## **SUBMISSION TO AMENDMENT C295case TO THE CASEY PLANNING SCHEME CASEY FIELDS SOUTH & DEVON MEADOWS PRECINCT STRUCTURE PLAN**

proUrban is pleased to provide this submission to the Victorian Planning Authority (VPA) in relation to exhibited Amendment C295case ('the amendment') to the Casey Planning Scheme – Casey Fields South and Devon Meadows Precinct Structure Plan (PSP).

Figure 7 - Alternative staging plan based on exhibited PSP

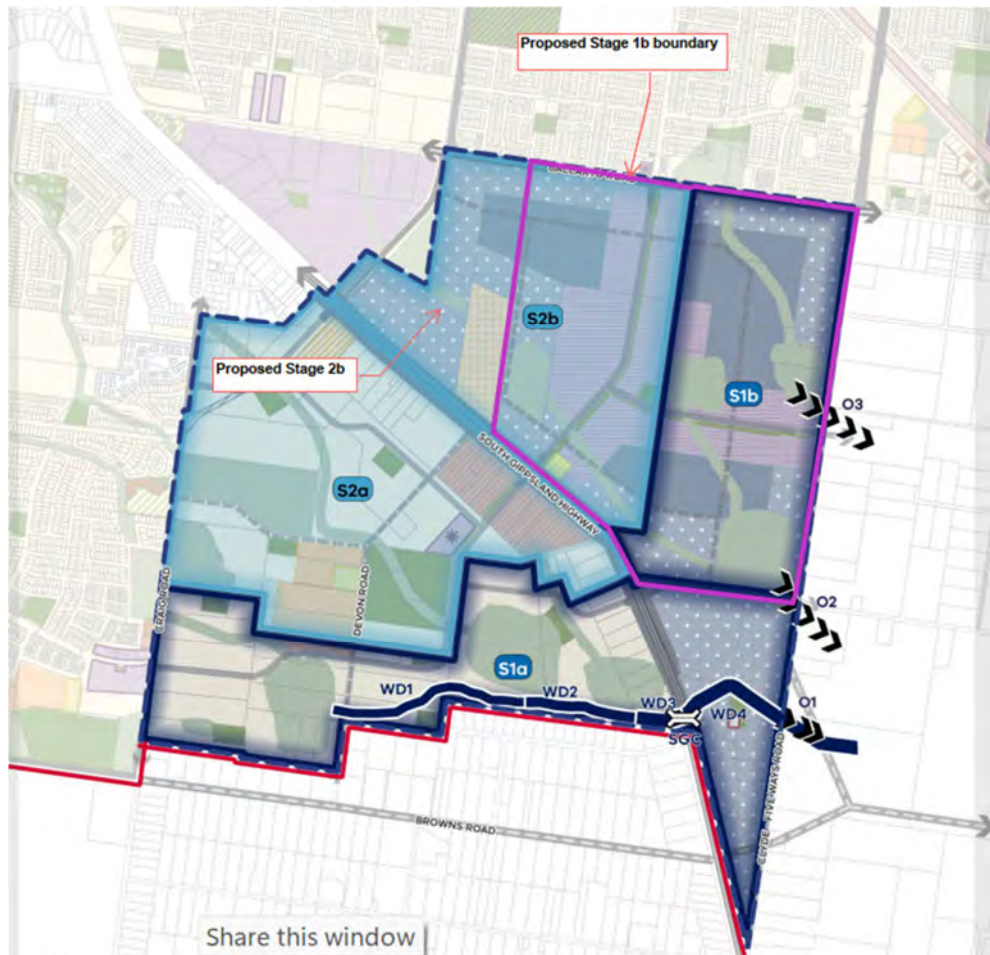
The current staging plan stifles the ability for other parts of the CFS PSP to be implemented earlier as stage 1b is predicated on the basis that a drainage outfall can be achieved. There is no evidence or timeframe around securing an outfall and thus Stage 1b boundaries should be increased further west to enable some of the PSP to be implemented in the event no outfall is realised in the short to medium term

The revised staging plan also enables alternative access points into the PSP.

**RECOMMENDATION** - Our opinion is that VPA should consider the below alternative staging plan.

Figure 2: PSP Movement Network Plan

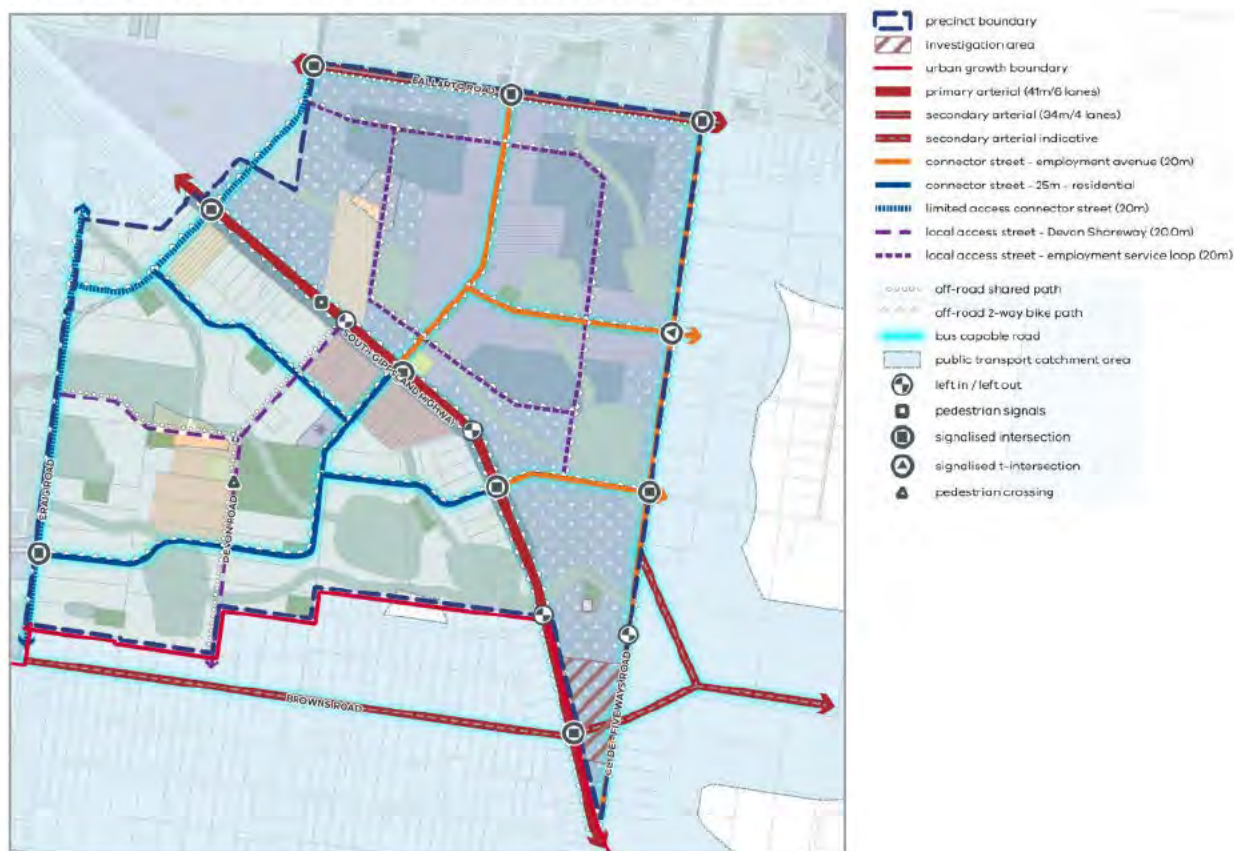
- A continuous loop road and cross-intersections are not required to facilitate efficient access to the proposed employment land, and alternatives exist which effectively manage heavy vehicle movement between PSP properties and the external arterial road network. Local streets are not ICP items and do not connect directly to the arterial road network. Accordingly, it would not be inappropriate to remove these from the PSP and allow the internal PSP local street network to be guided by market conditions and standard road network design principles at the time of development.

Figure 5: Proposed Staging Boundaries

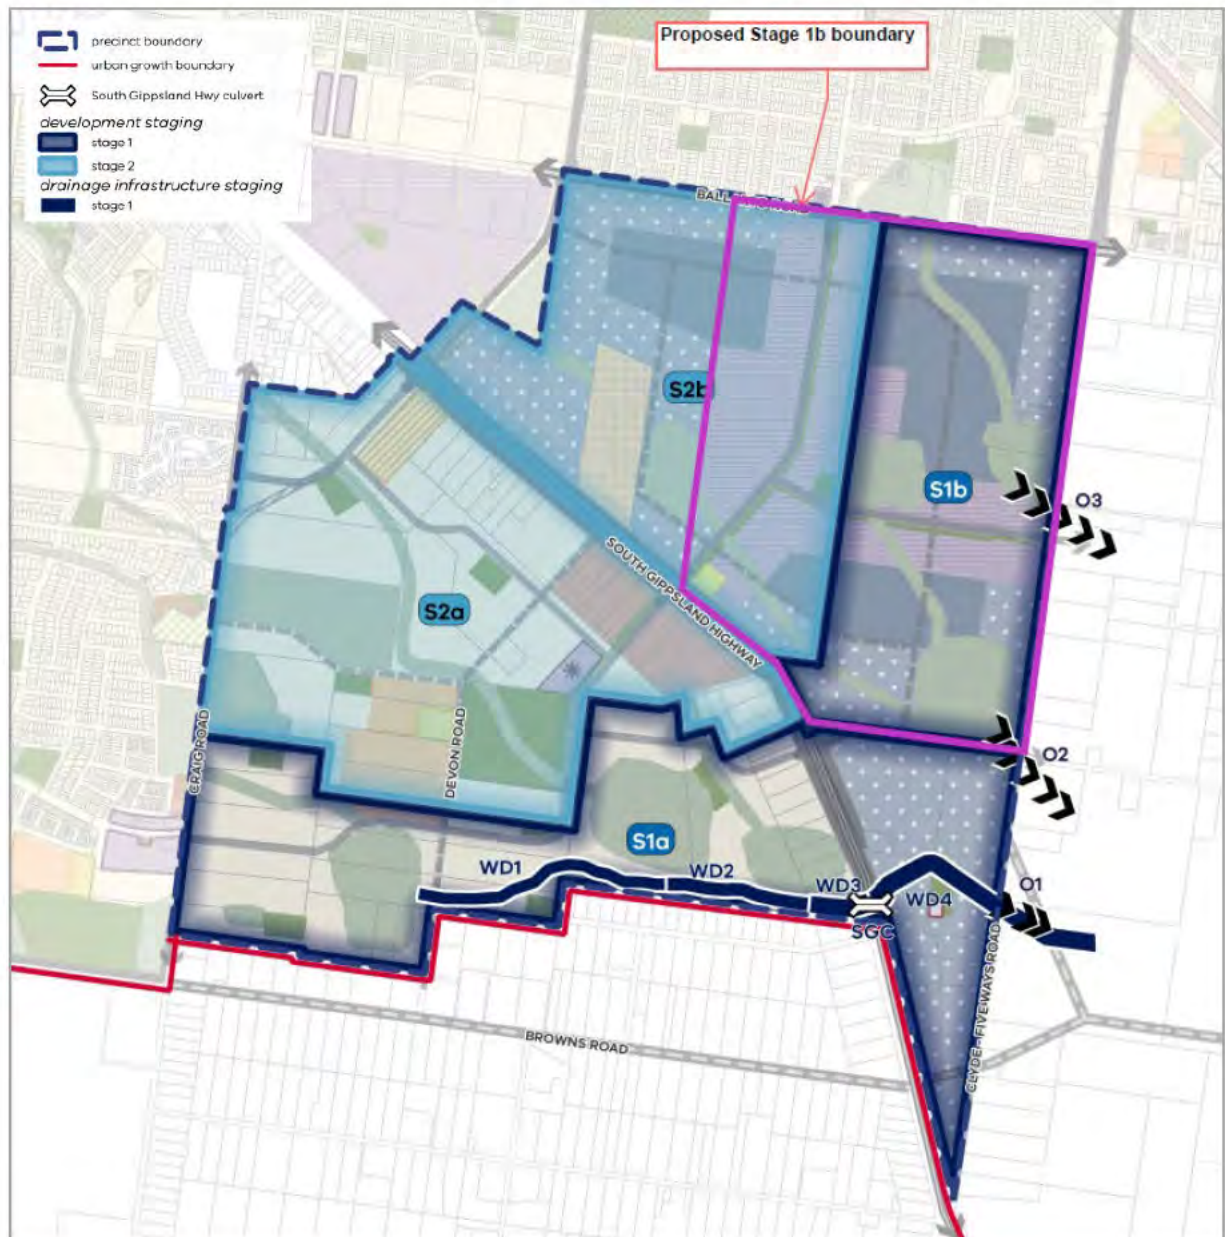
It is proposed to alter the staging boundary for Stage 1b to include the connector road intersections to South Gippsland Highway and Ballarto Road (IN-02 and IN-05).

Adding properties CF-05 and CF-20 to Stage 1b would result in an increase of Stage 1b traffic in the order of 9,000vpd. Importantly, the revised staging boundary spreads the traffic across all three arterial road frontages via at least three arterial road connections (IN-02, IN-05 and IN-06).

Figure 6: Casey Fields (Employment) PSP – Secondary Arterial Cross-Section (Proposed)

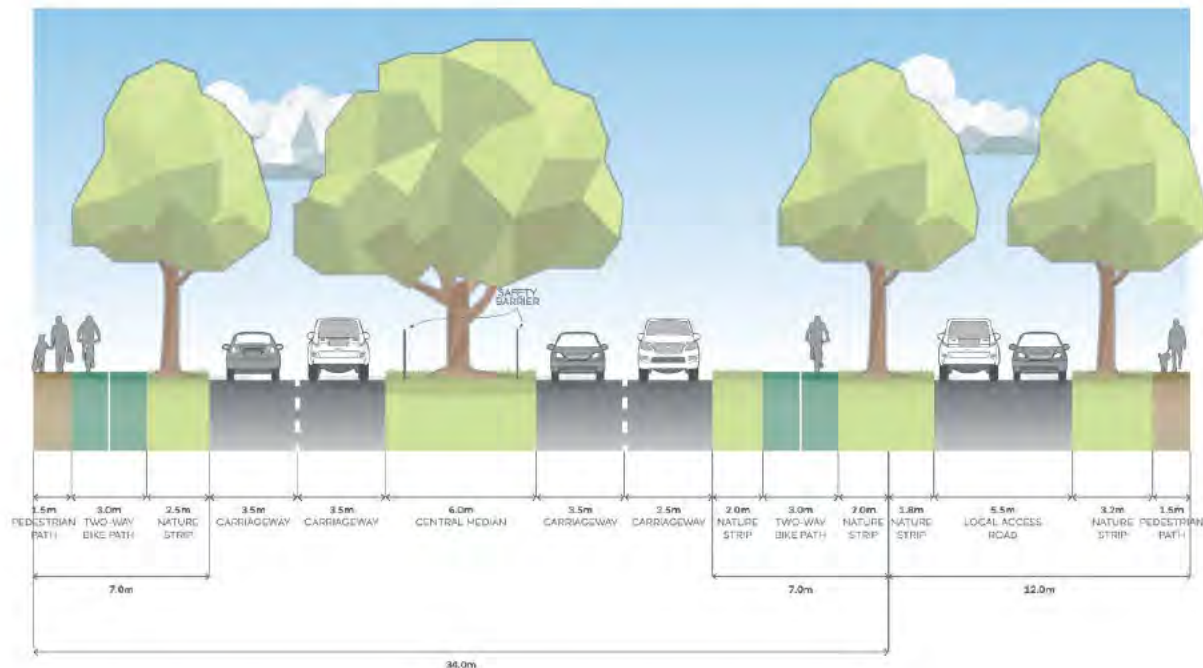
- 34m is a standard reservation width for a four-lane secondary arterial road.
- The reservation appears to apply to Ballarto Road as it is the only identified secondary arterial road within the Movement Network Plan.

- The “plan view” is based on residential frontages on both sides, which is not relevant in this instance, and shows footpaths provided within the 34m road reservation on one side but required to be provided outside of (in addition to) the 34m road reservation on the other side.

- Where the footpath is provided within the road reservation, it is hard up against the two-way bike path with no separation.
- There is no provision for on-street parking. This is common on PSP arterial roads. Parking is typically provided on frontage roads or service lanes and not on the main arterial road carriageway.

Figure 8: Casey Fields (Employment) PSP – Connector Street – Employment Avenue Cross-Section (20m)

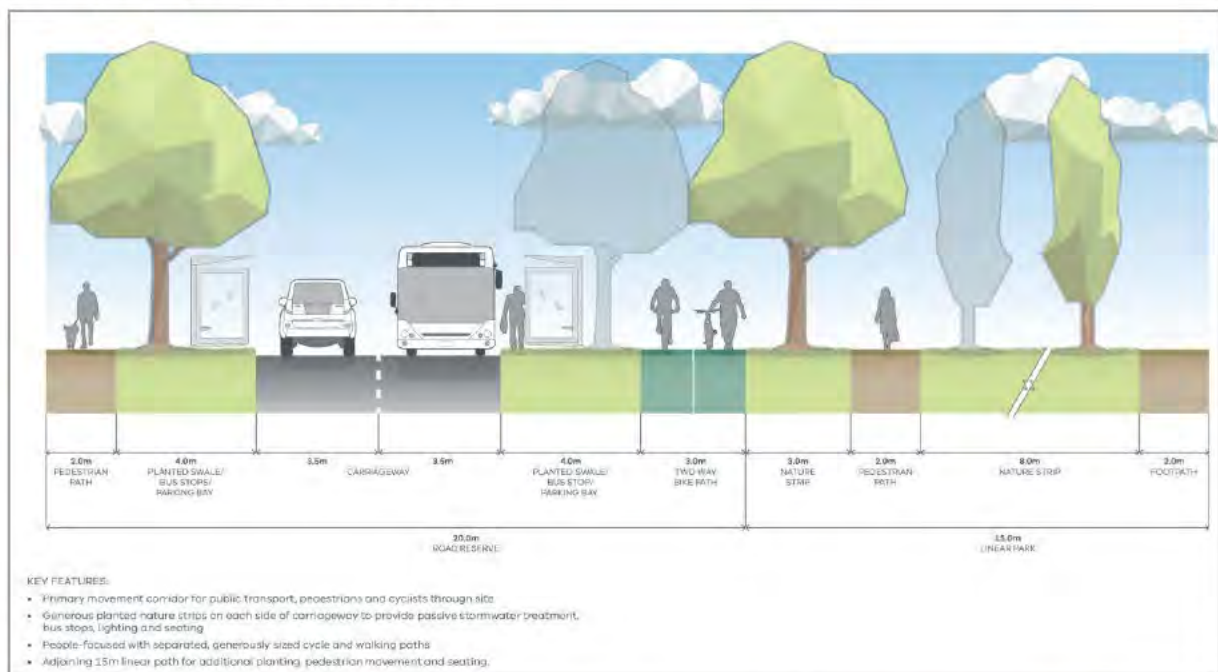
- A 7m wide carriageway (two 3.5m lanes) is well below the typical provision for an industrial subdivision and does not meet the Public Transport Guidelines for Land Use Development, which shows a minimum 8.4m carriageway for bus-capable roads where separate on-road cycle lanes are not included.

- The "key features" notation refers to the proposed nature strips as ... *"generous planted nature strips on each side of the carriageway to provide passive stormwater treatment, bus stops, lighting and seating"*. However, the cross-section shows the 4m verges are required to accommodate planted swale, bus stops and parking bays. In industrial estates parking bays are required to be a minimum of 2.6m wide to cater to heavy vehicles. There will be minimal space for swales and any planting of trees will need to be widely spaced to allow for truck layovers.

Figure 9: Casey Fields (Employment) PSP – Local Access Street – Employment Service Loop Cross-Section (20m)

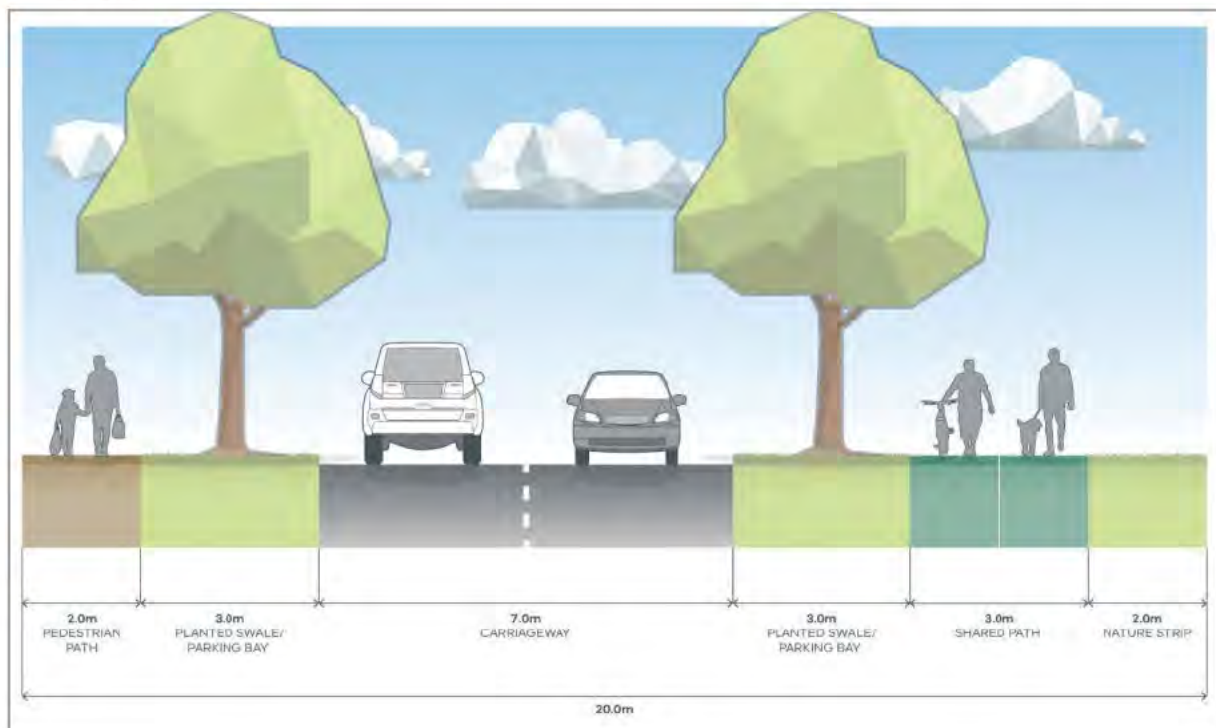
- The "key features" notation refers to ... *"generous planted nature strips on each side of carriageway to provide passive stormwater treatment, parking, lighting and seating"*. The nature strips are only 3m wide and are also proposed to accommodate a planted swale in addition to indented car parking and canopy trees. Indented truck parking bays need to be long enough for articulated trucks, leaving little room for planting. In an industrial/employment estate there would typically be a reasonable provision for on-street

parking (including for truck layover). Additionally, truck parking bays need to be a minimum of 2.6m wide, leaving only 0.4m for the planted swale.

The three connector street intersections are shown in the diagrams below (extract of Plan 11).

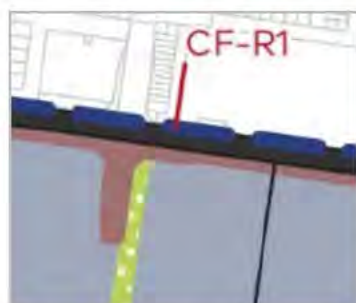
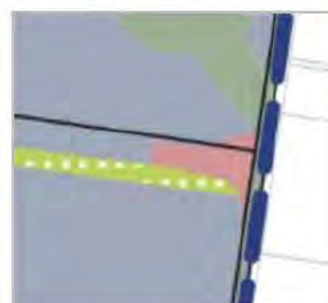
PSP Plan 11 indicates that intersections IN-05 and IN-06 are located predominantly within one title but have a small section which potentially extends across an adjacent lot in different ownership. This will make delivery of the intersections more difficult and should be avoided if possible.

Additionally, IN-05 does not appear to include any splays. It is noted that there is an existing wide verge on South Gippsland Highway and it is likely that the splays can be accommodated within the existing road reservation. However, this should be confirmed within the PSP with the inclusion of an intersection plan as DTP sometimes requires the verge width to be maintained at intersections which requires splays to accommodate turn lanes and impacts on developable area.
